CHANGE ORDER

No.: 1

Table with contract details: Project: Madison Street & Green Alley Projects, Owner: City of Charlestown Redevelopment Commission, Owner's Contract No., Contract: Madison Street & Green Alley Projects, Date of Contract: September 29, 2025, Contractor: Libs Paving Company, Inc., Engineer's Project No.: 1427.000

Description: Removal of curb ramp and replacement based on revised design at the corner of Madison Street & Green Alley.

Attachments (list documents supporting change): Revised curb ramp layout with construction notes

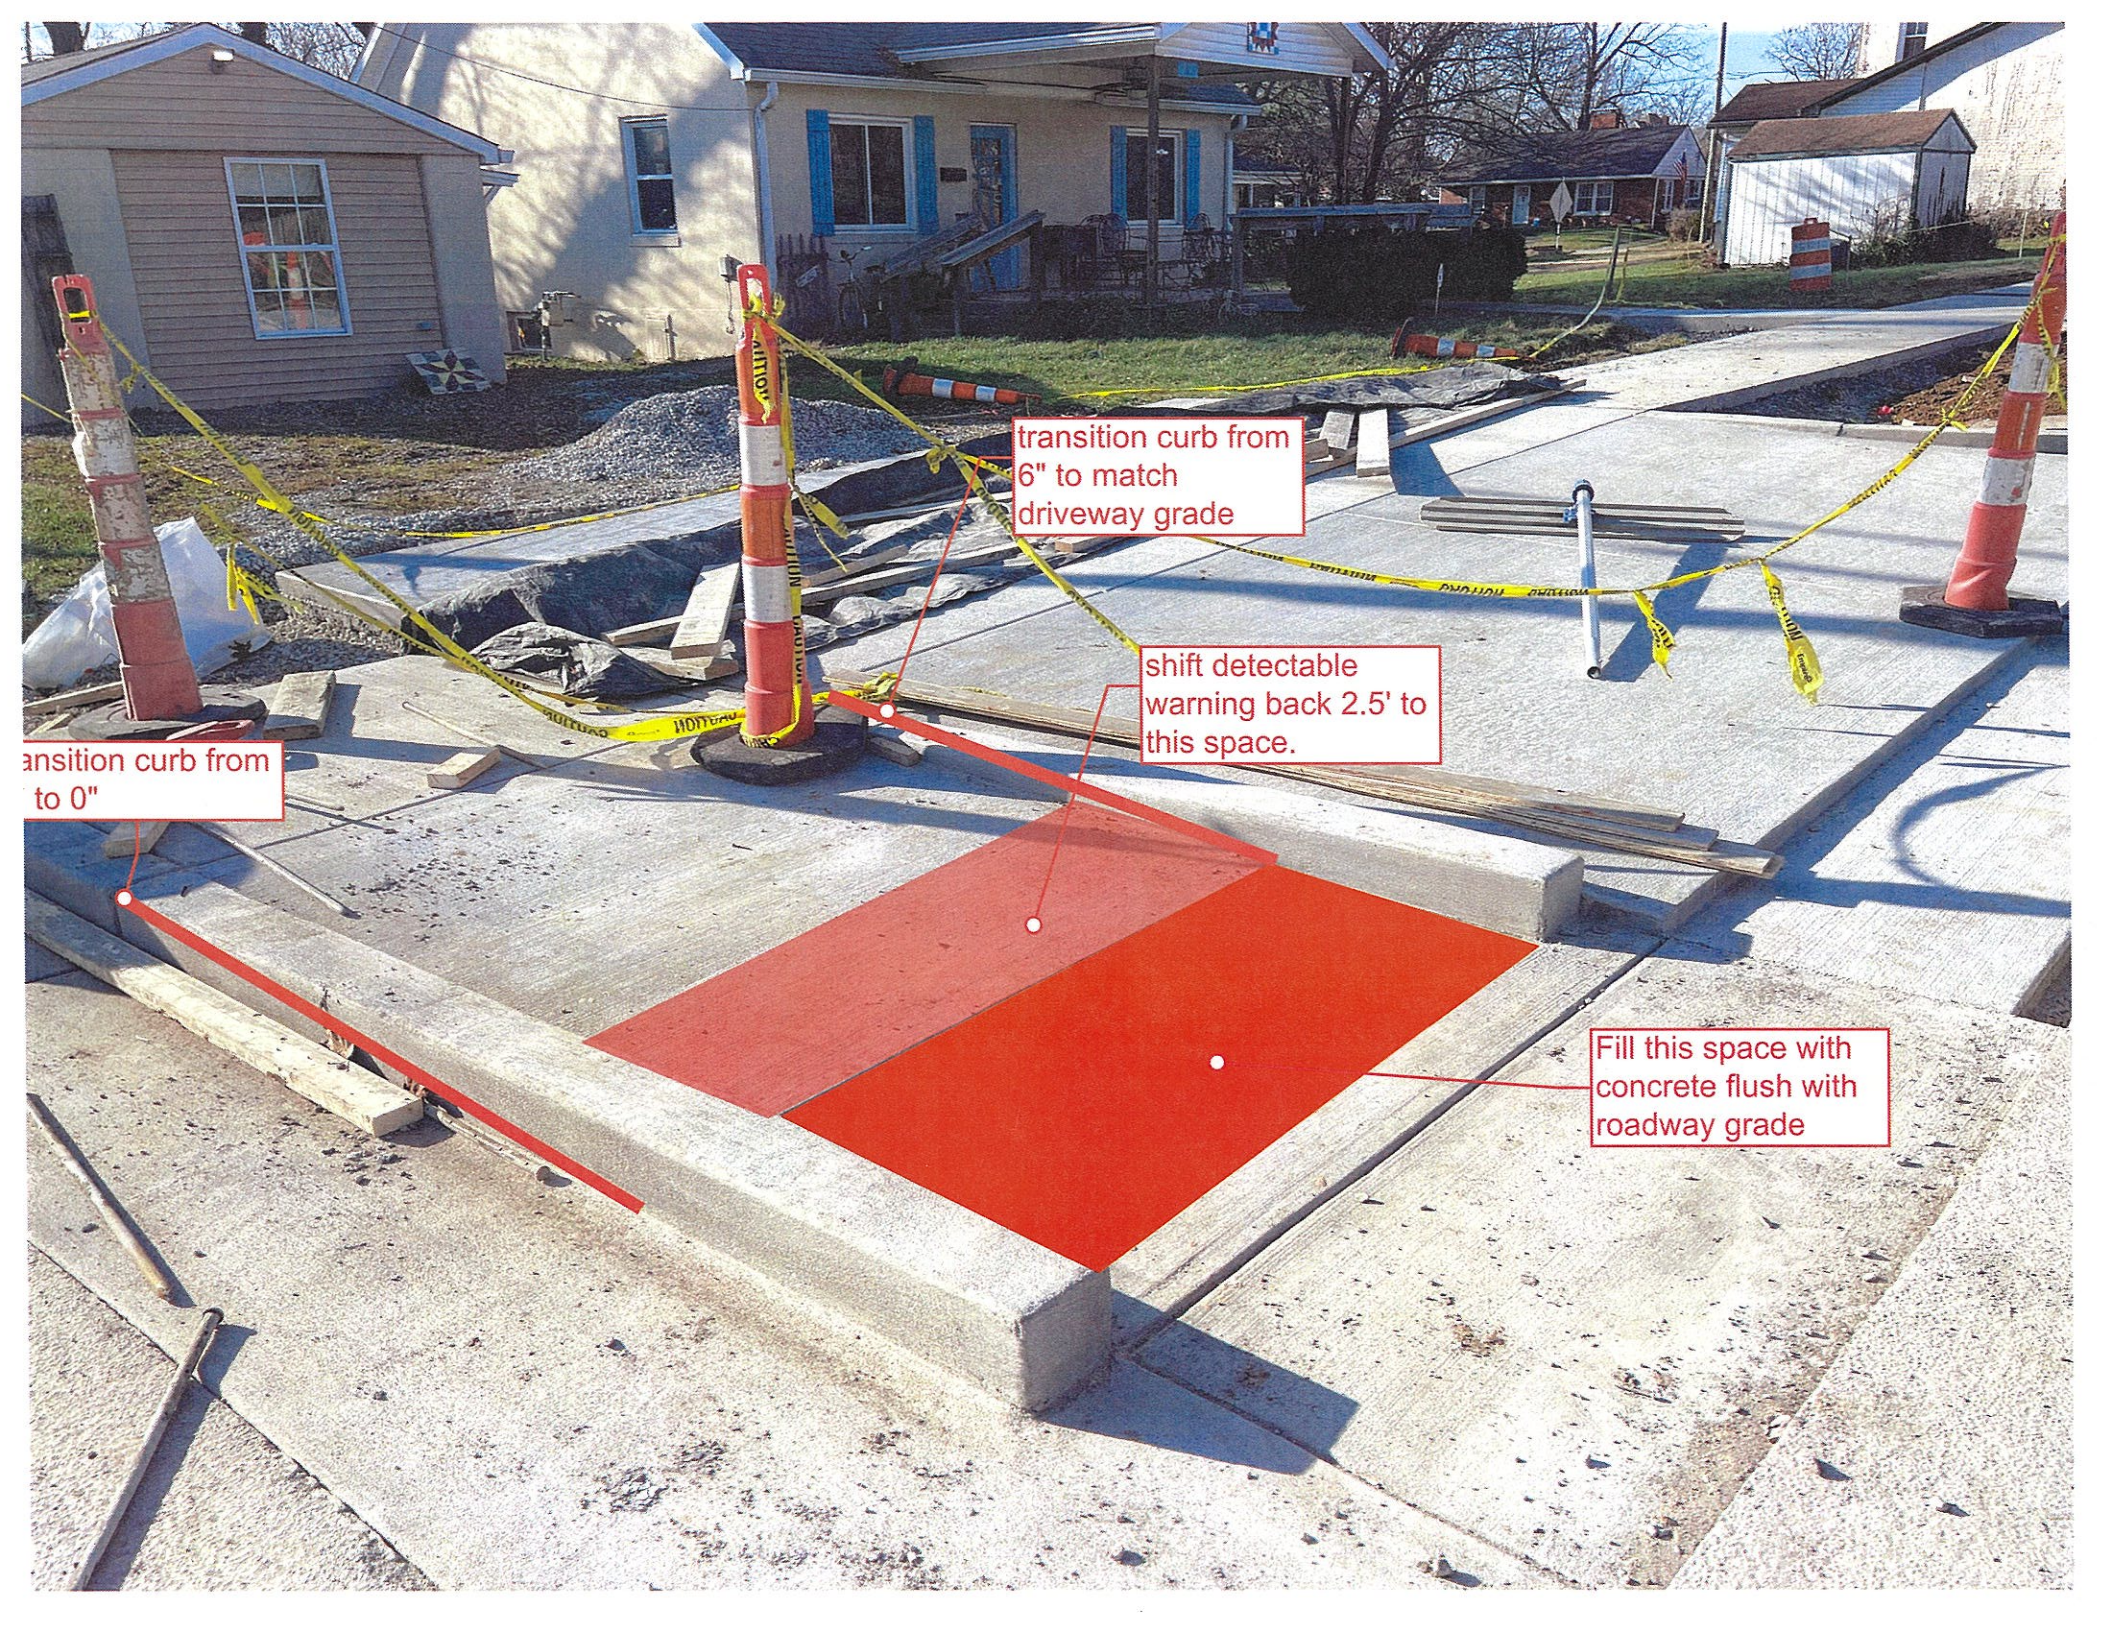
transition curb from 6" to match driveway grade

shift detectable warning back 2.5' to this space.

Fill this space with concrete flush with roadway grade

transition curb from 6" to 0"
